Office Action Summary	Application No. 10/795,891	Applicant(s) LAKIN ET AL.	
	Examiner MARY HOFFMAN	Art Unit 3733

DETAILED ACTION

Claims 1-42 and 60-73 are rejected under 35 U.S.C. 103(a) as being unpatentable over Duvillier et al. (U.S. Patent No. 5,749,876)

5,749,876

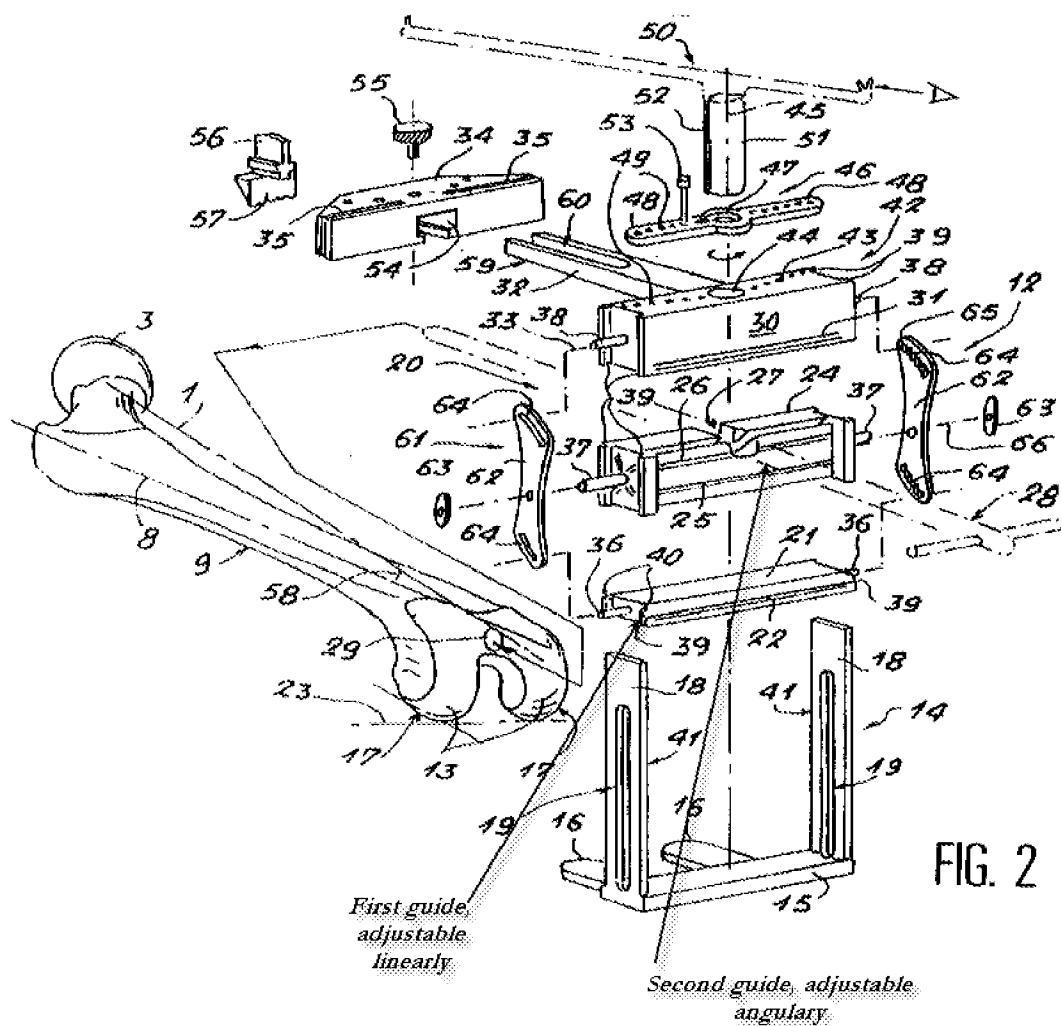
Applicant's arguments filed 10/17/2007 have been fully considered but they are not persuasive. Applicant argues that the device of Duvillier et al does not include a first guide defining a first cutting path having a position, the position of the first cutting path relative to the first mounting location being adjustable linearly using a grip of the first adjustor and a second guide defining a second cutting path having a position, the position of the second cutting path relative to the first mounting location being adjustable angularly using a grip of the second adjustor. The examiner respectfully disagrees. Duvillier discloses a first guide defining a first cutting path having a position, the position of the first cutting path relative to the first mounting location being adjustable linearly using a grip of the first adjustor and a second guide defining a second cutting path having a position, the position of the second cutting path relative to the first mounting location being adjustable angularly using a grip of the second adjustor (e.g., see the marked up figure below).

Also, in FIG. 2A, components ref. #30 and 205 appear angularly adjustable.
